SUBJECT: TECHNICAL SPECIFICATION CHANGE REQUEST RELATED TO THE FIRST REFUELING OF THE REACTOR WITH NEW FUEL TYPES AND TO SUPPORT SUBSEQUENT REACTOR OPERATION (CYCLE 2) IN THE MAXIMUM EXTENDED OPERATING DOMAIN (MEOD) AND WITH REDUCED FEEDWATER TEMPERATURE (TAC NO. 69308)

Re: CLINTON POWER STATION, UNIT NO. 1

AMENDMENT TO FACILITY OPERATING LICENSE

Amendment No. 18
License No. NPF-62

Figure 3.2.1-1 Flow-Dependent MAPLHGR Factors (MAPFAC_f)

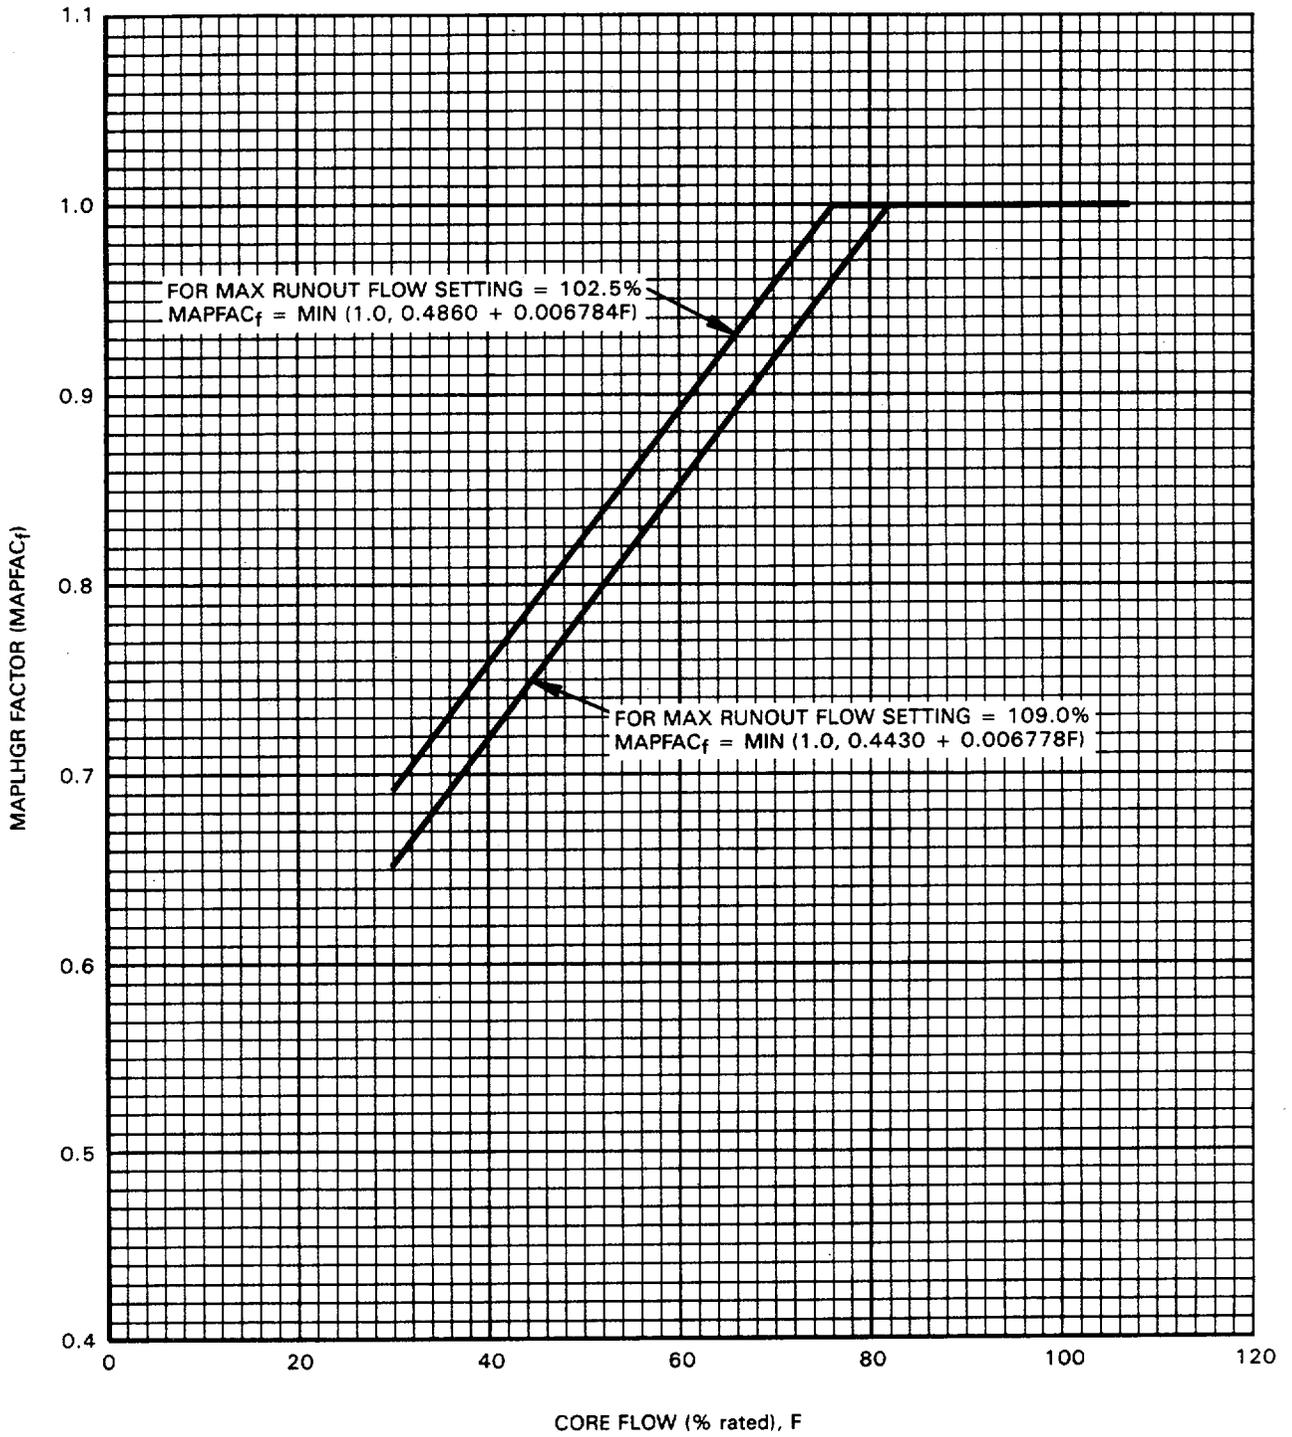
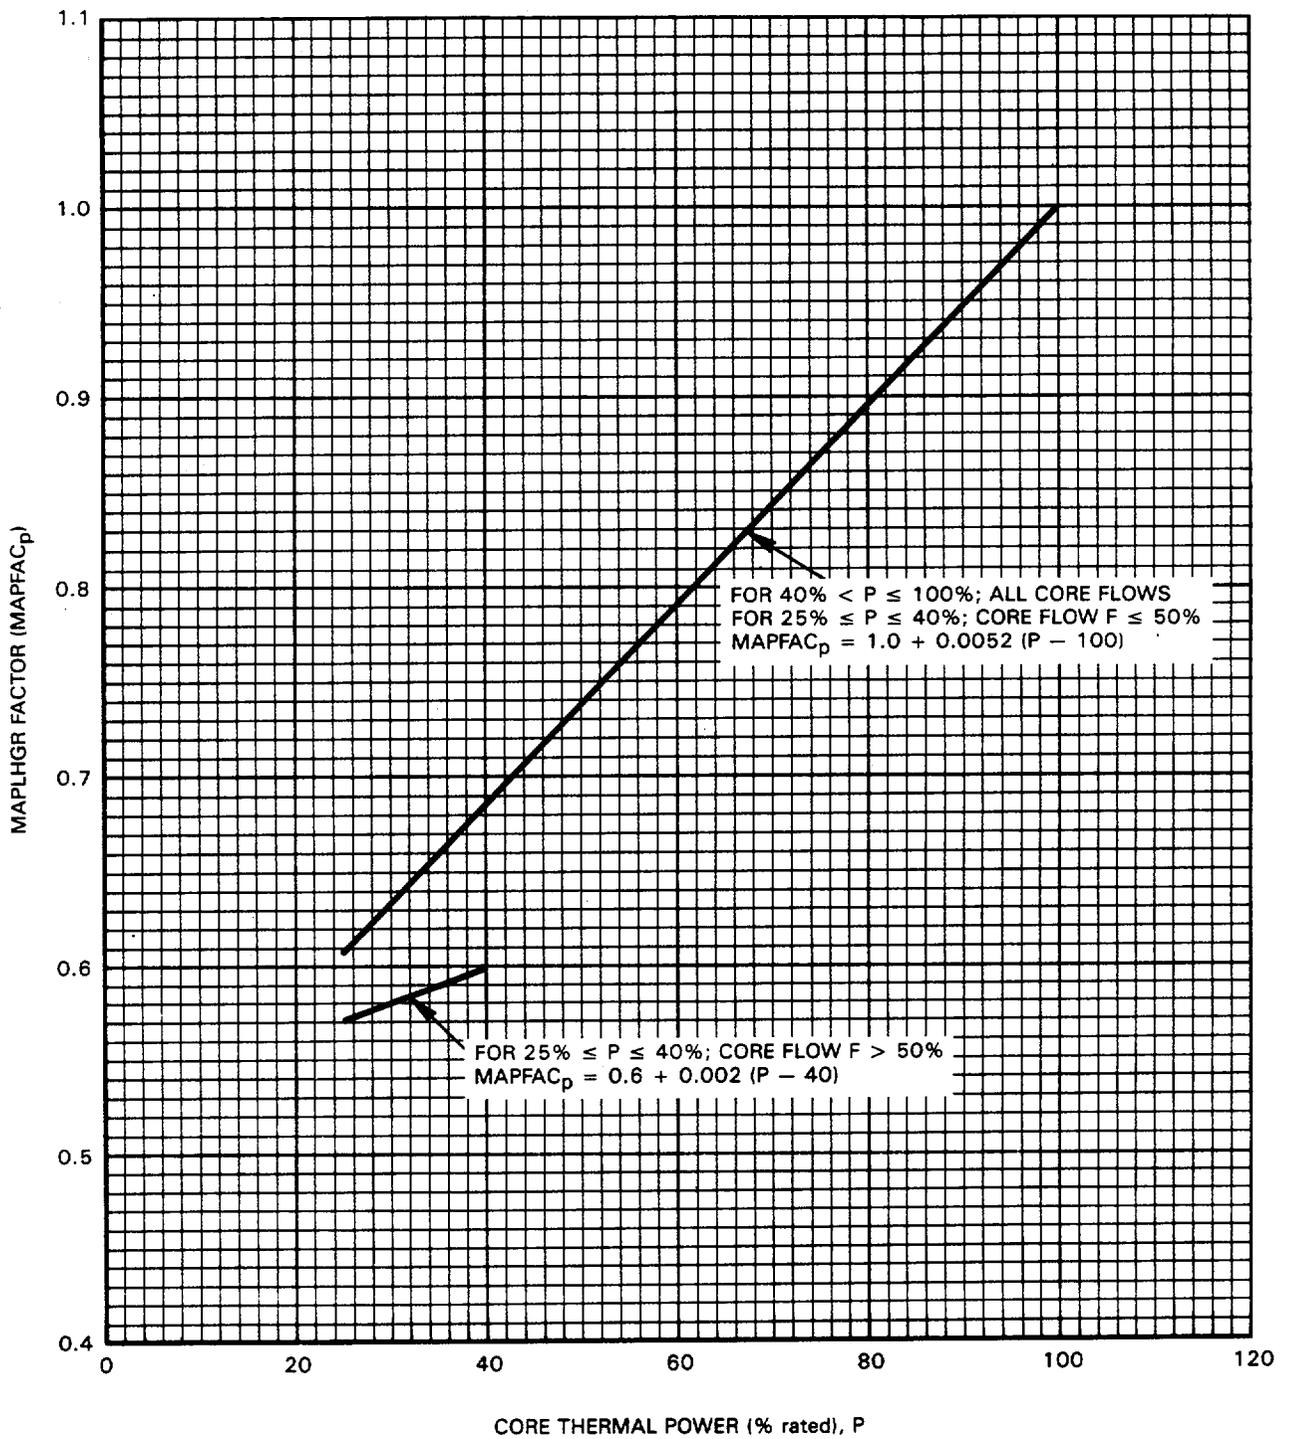
T/S Bases 3/4.2.1: A paragraph is being added to this section to discuss how $MAPFAC_f$ and $MAPFAC_p$ are to be used, and how $MAPFAC_f$ and $MAPFAC_p$ are determined.

Figure 3.2.3-1 Clinton MCPR_f Versus Core Flow

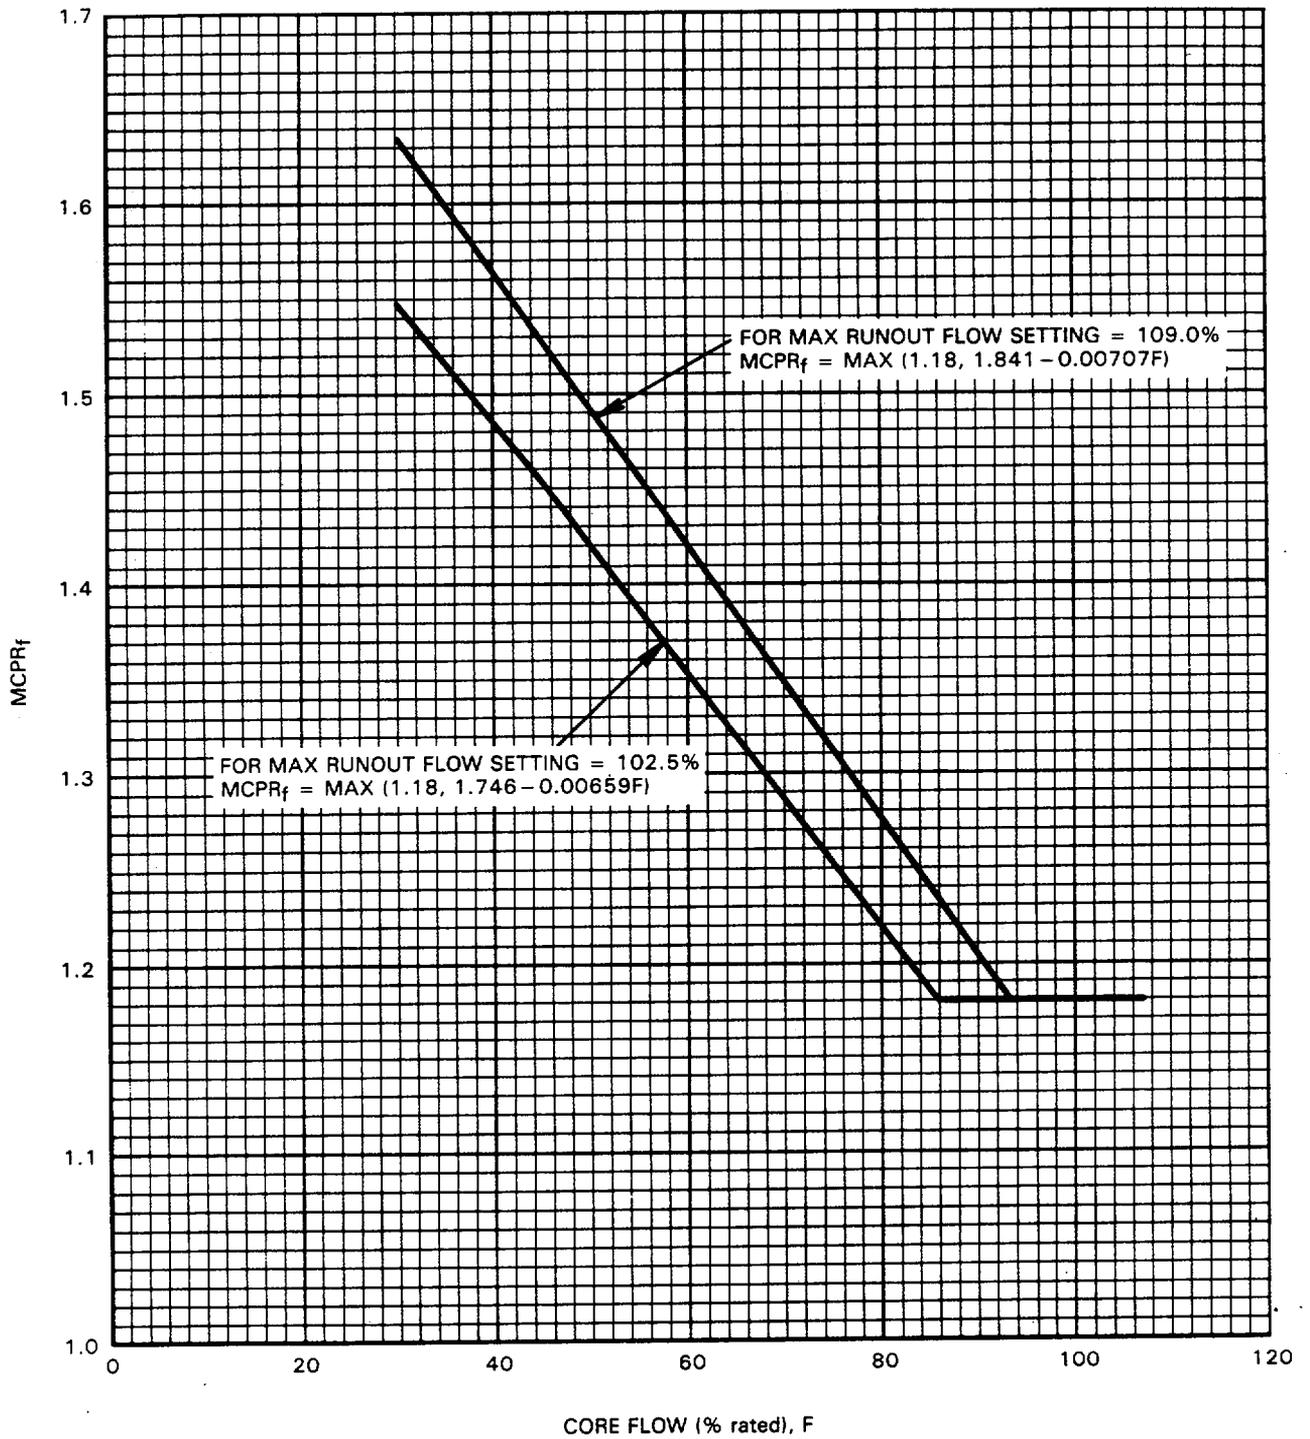
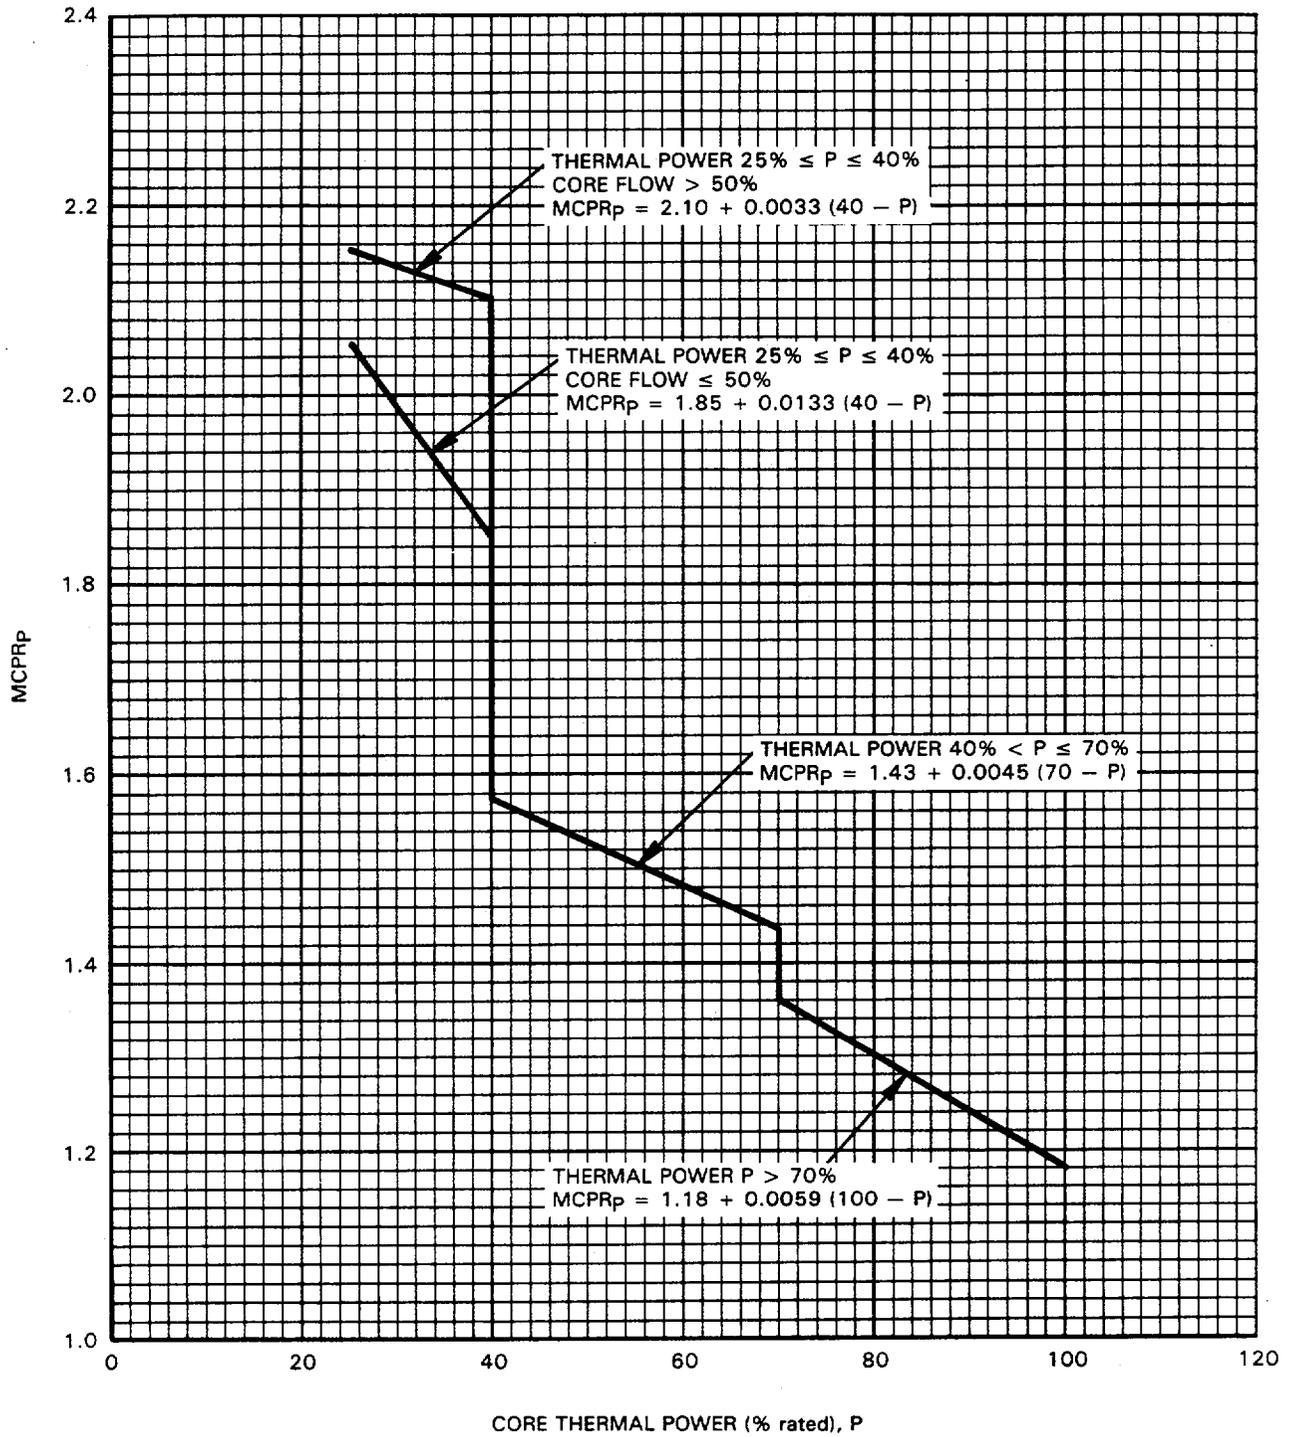
The operating limit MCPR at any power/flow condition is the larger of the new $MCPR_f$ and the $MCPR_p$. The new values are presented in the revised Figures 3.2.3-1 and 3.2.3-2. The changes are acceptable.

Bases Figure B 3/4.2.3-1 Reactor Operating Map for Two Recirculation Loop Operation

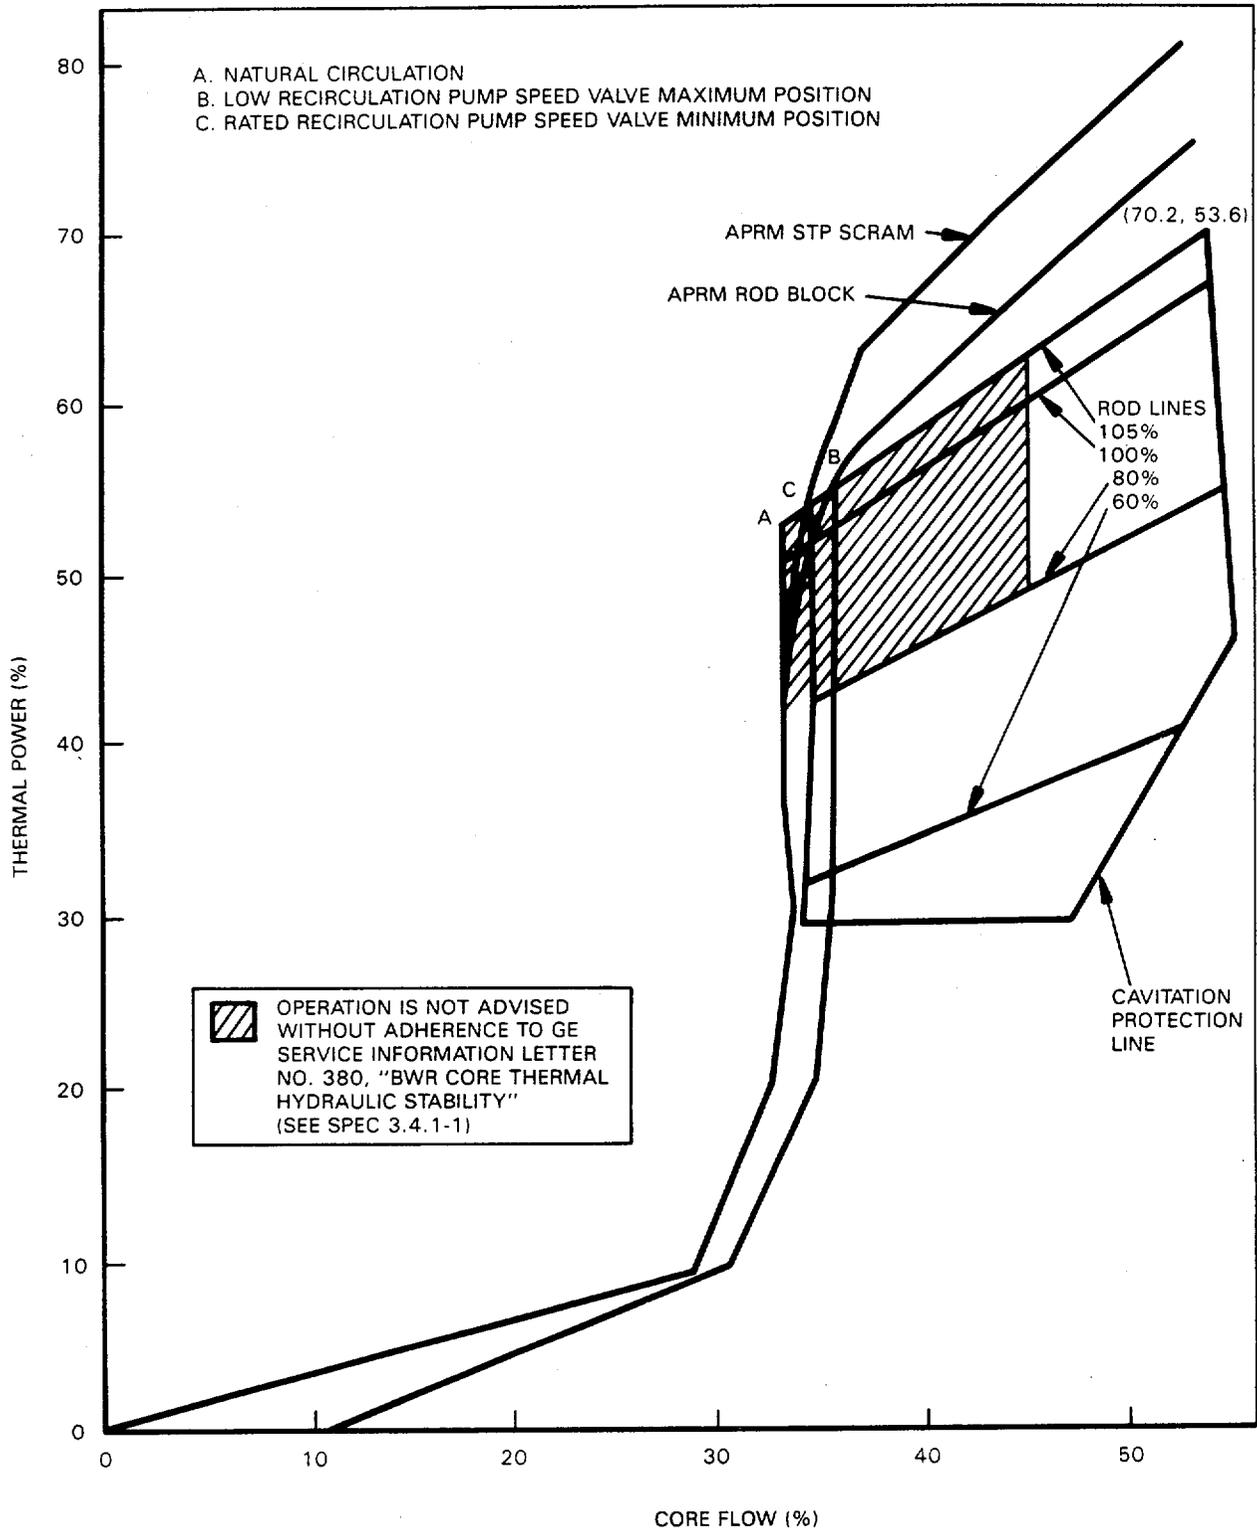
T/S Bases Figure B 3/4.2.3-1: This change revises the CPS operating map. The map is being revised to show the boundary of operation allowed by the MEOD. The changes are acceptable.
